**DOCUMENT 00 90 00  
ADDENDUM**

**ADDENDUM NO. [4]                      Date: November 21, 2018**

**RE:                      GLENWOOD COMMUNITY SCHOOL DISTRICT  
ATHLETIC COMPLEX IMPROVEMENTS BID PACKAGE 2 REBID  
400 SIVERS ROAD  
GLENWOOD, IOWA 51534  
HSR PROJECT NO. 18005**

**FROM:                  HSR Associates, Inc  
100 Milwaukee Street  
La Crosse, WI 54603  
(608) 784-1830**

**M101R**

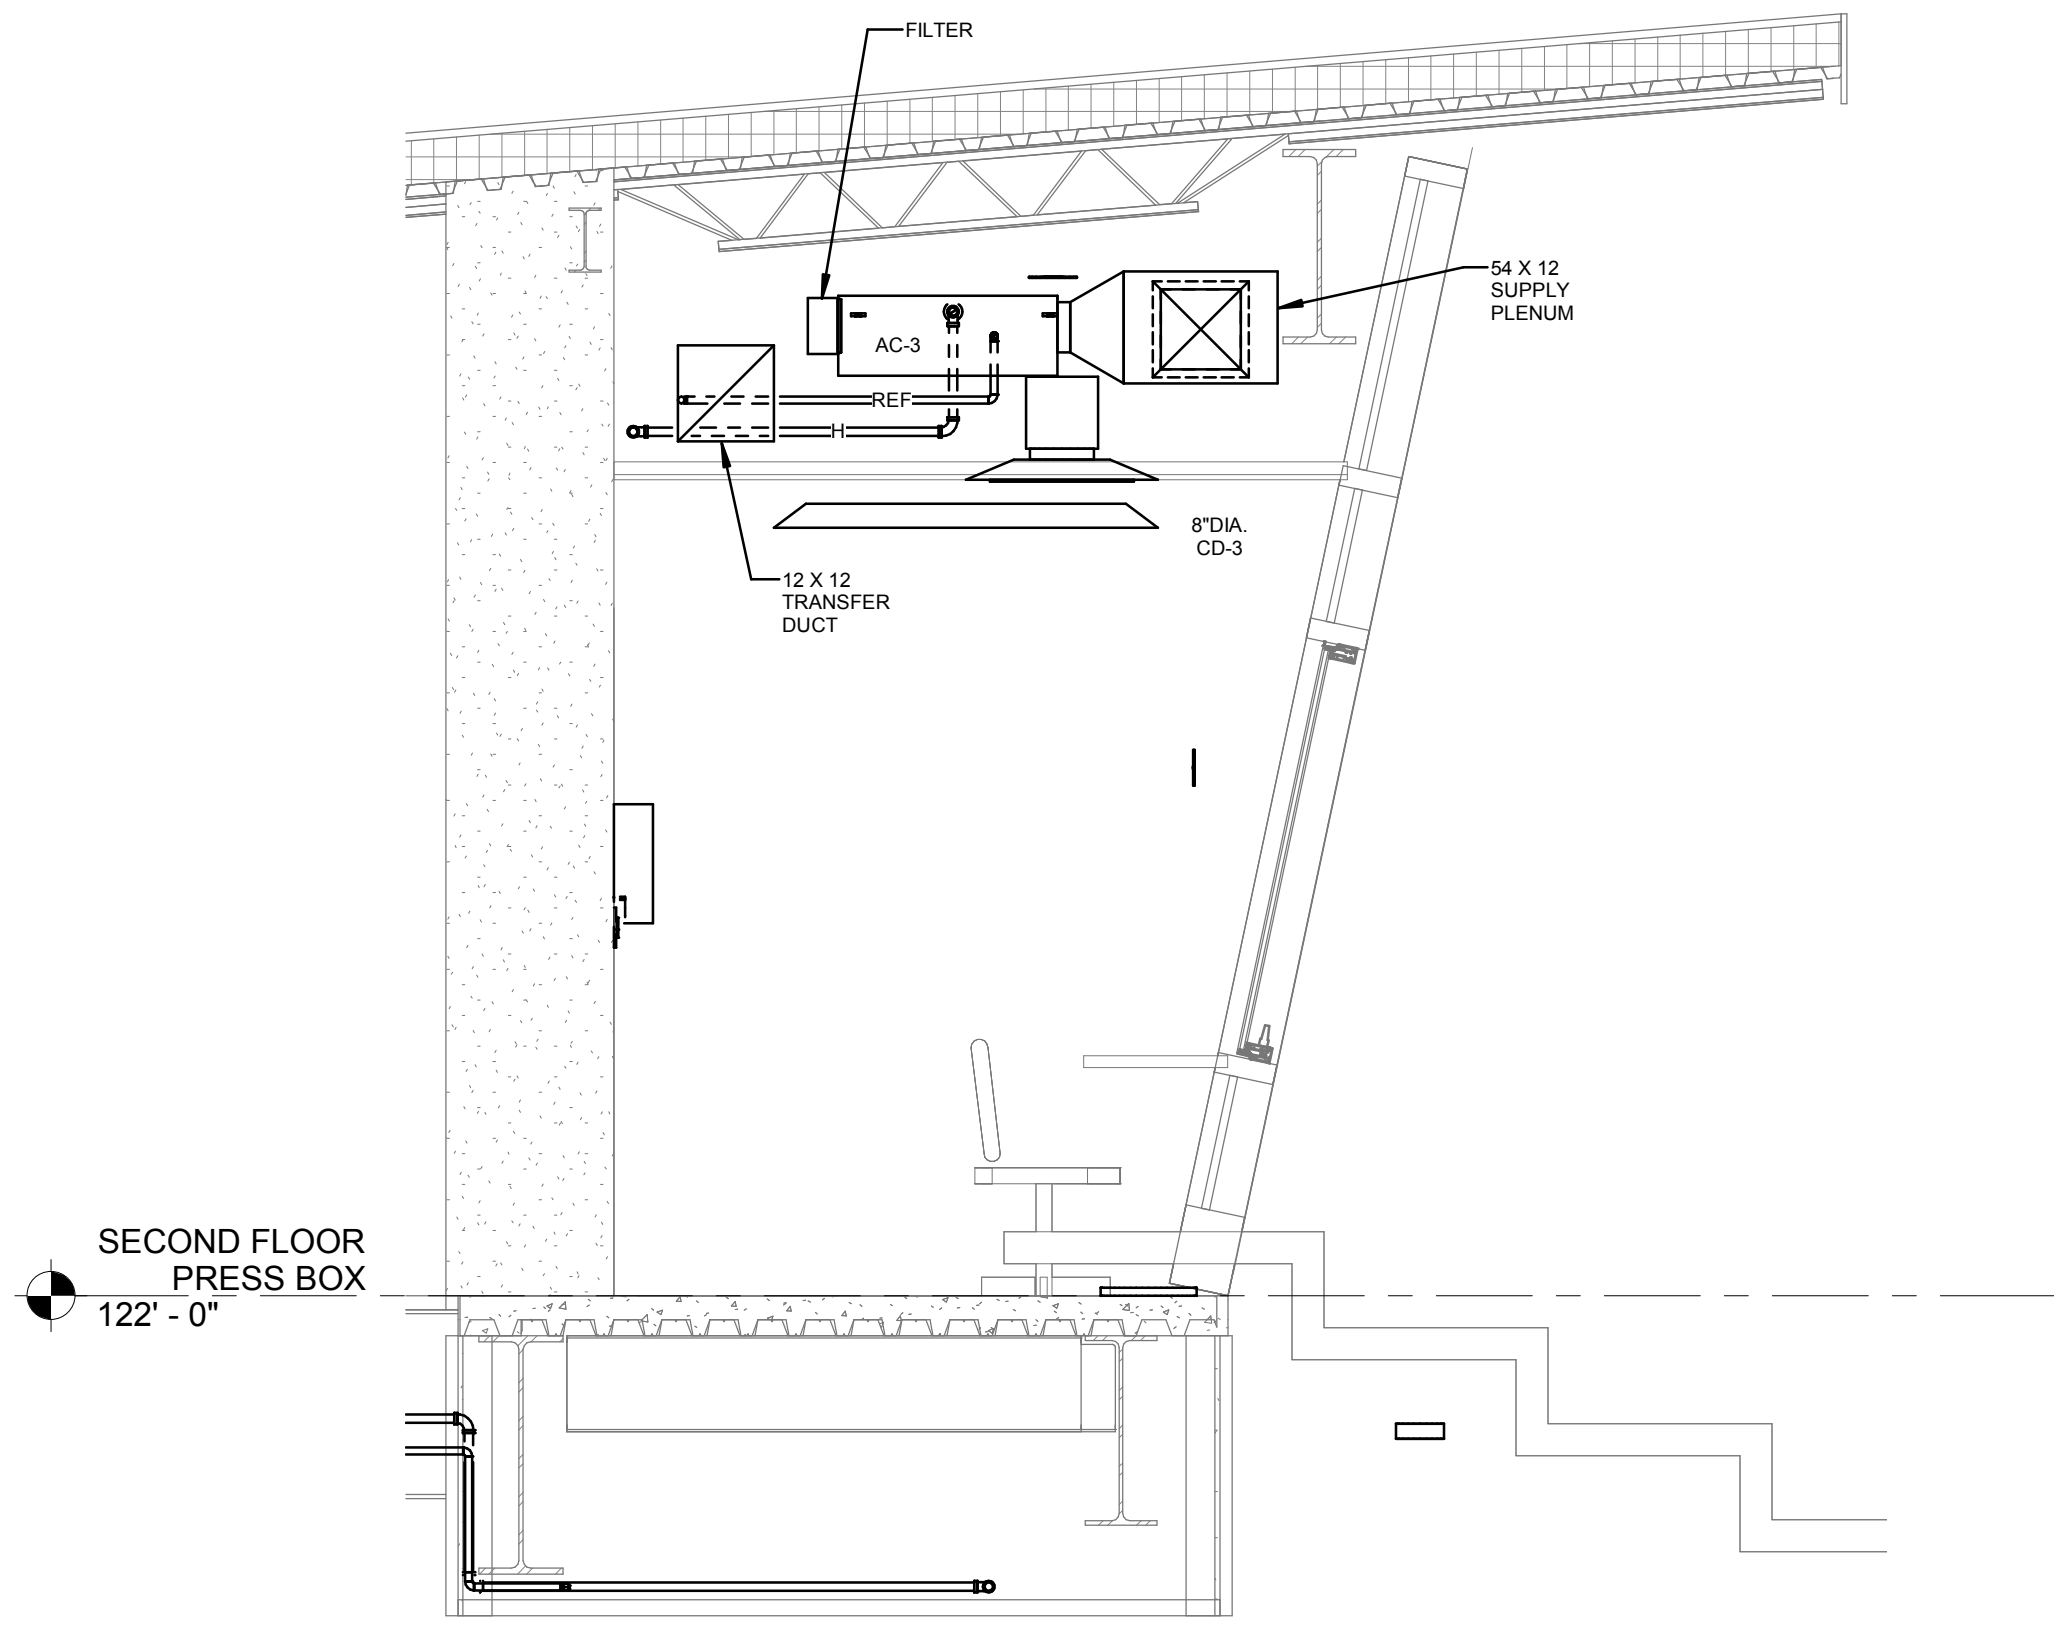
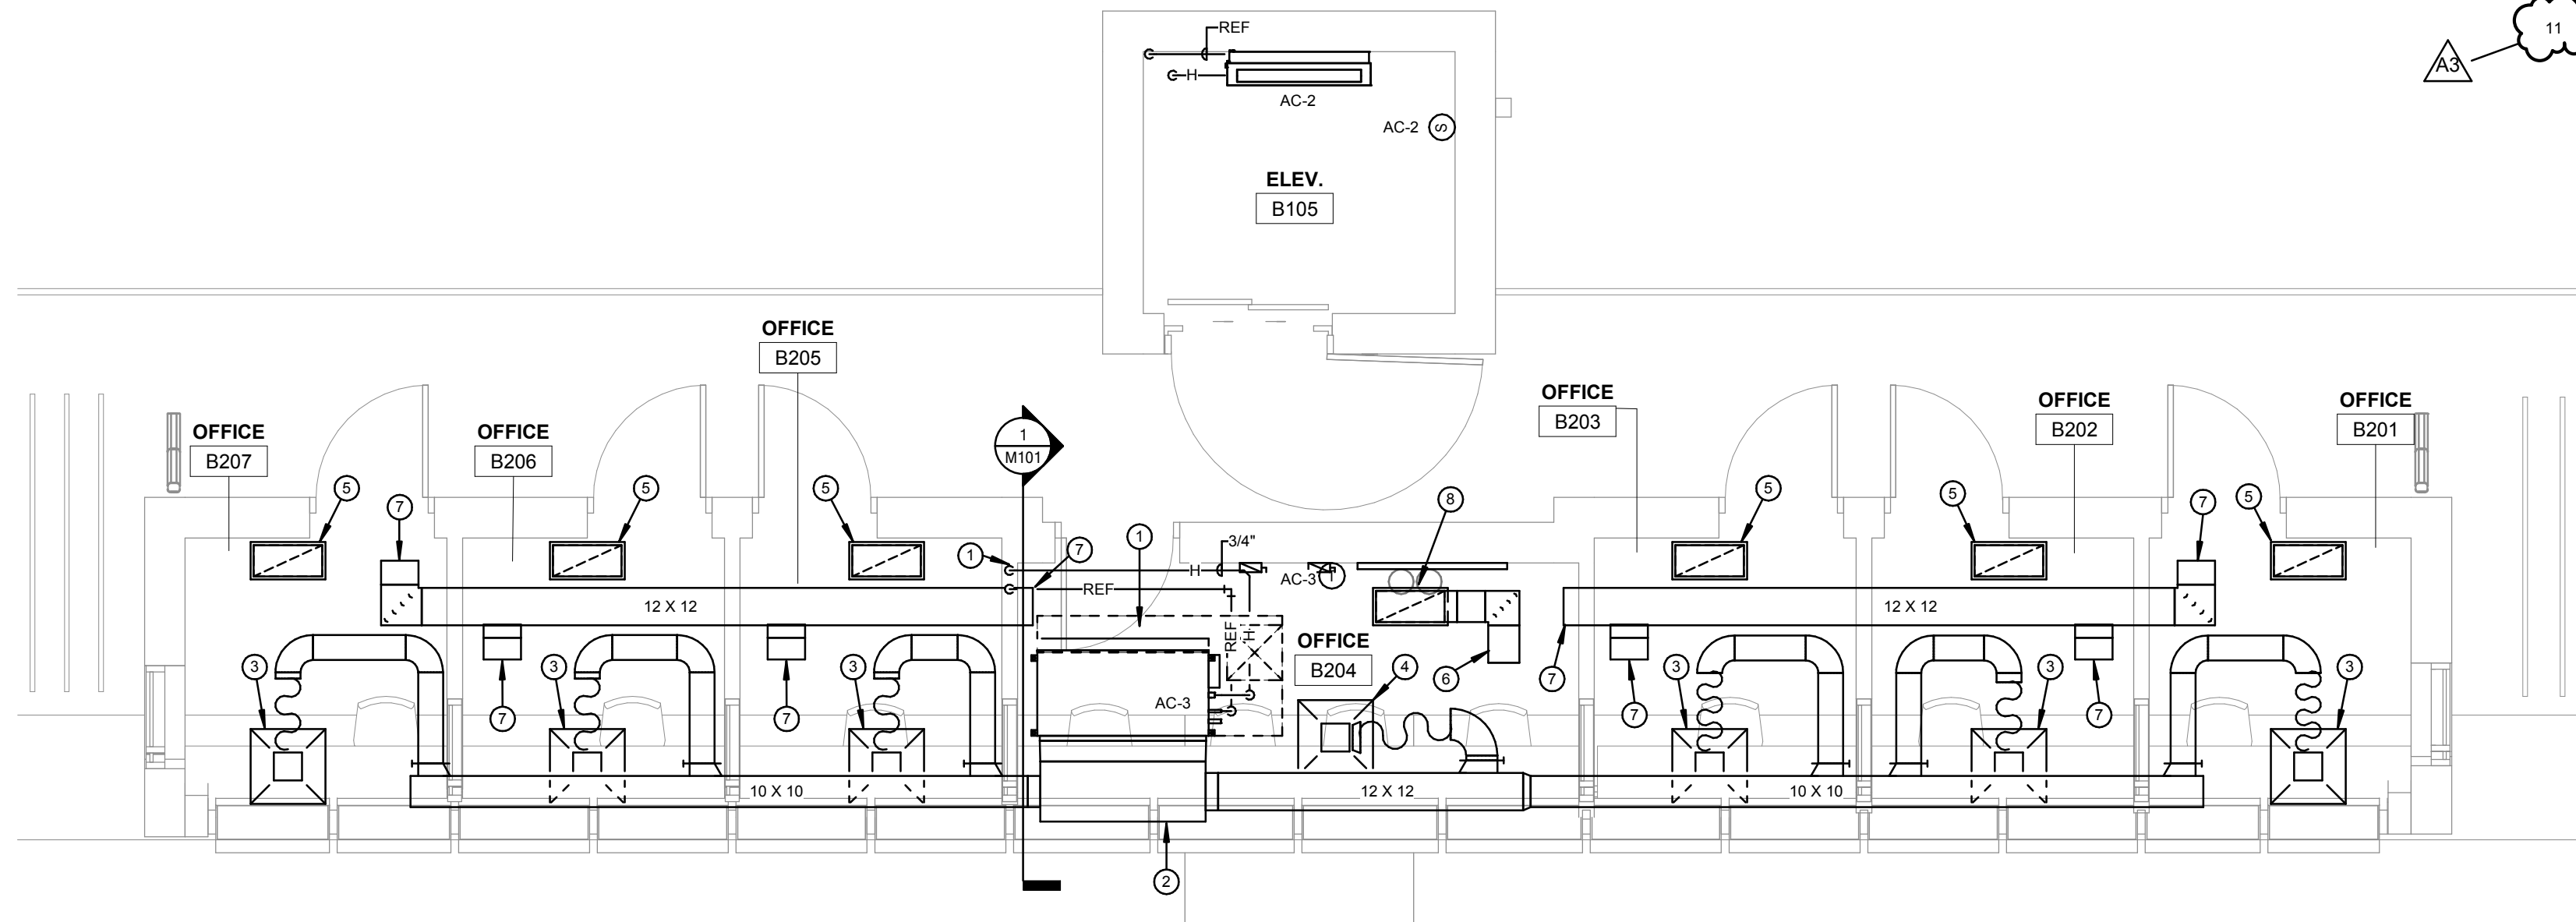
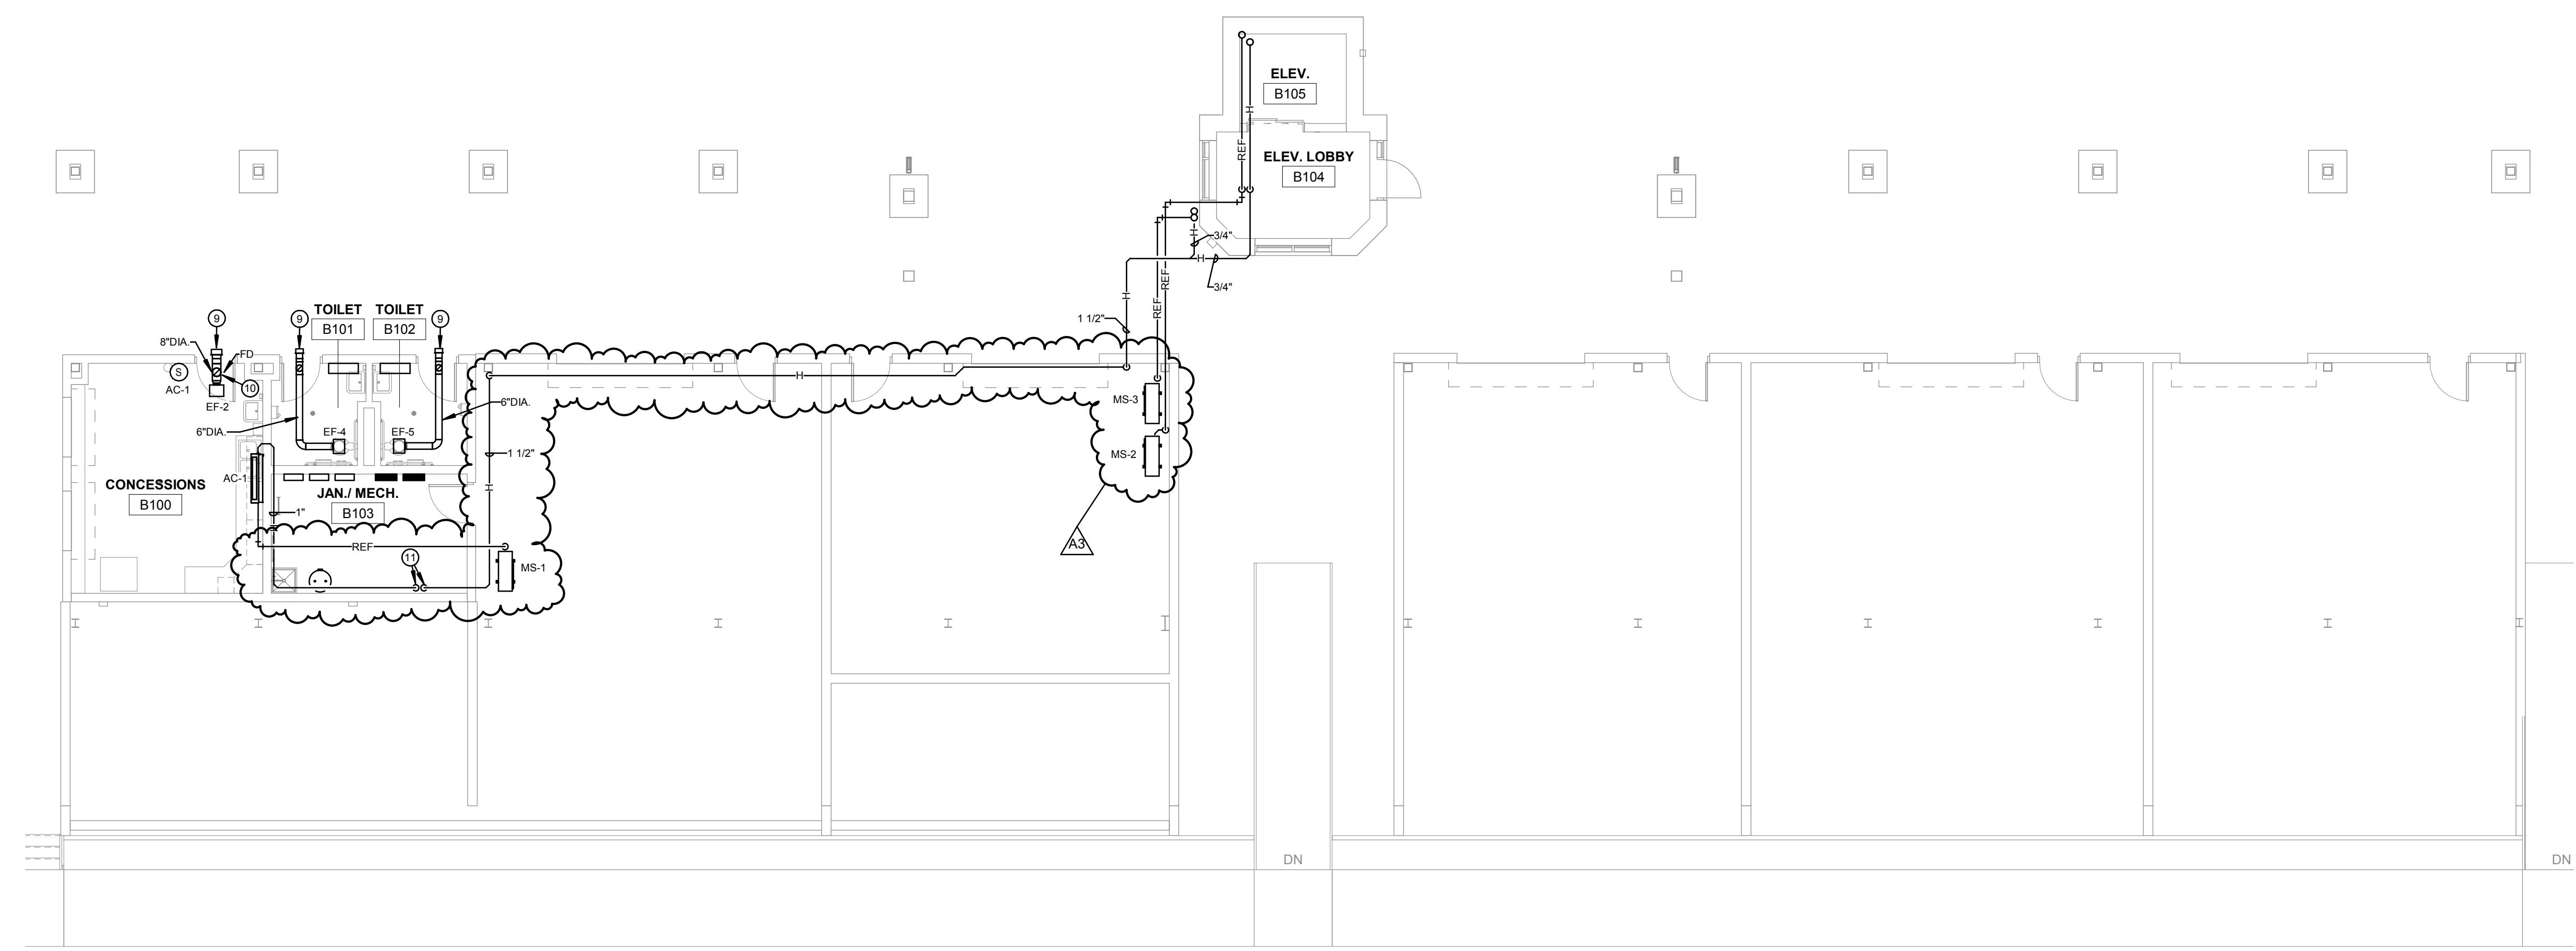
7. Sheet M101R STADIUM BUILDING HVAC PLAN 30 x 42 attached hereto.
- a. Revisions clouded on Drawing
  - b. Extend humidity drain pipe from (AC-1), (AC-2) & (AC-3) over to floor drain located in Jan. /Mech. B103.

- c. Relocated (MS-1), (MS-2) and (MS-3).
8. Sheet M103R HVAC SCHEDULES, DETAILS AND SYMBOLS 30 x 42 attached hereto.
- a. Revisions clouded on Drawing
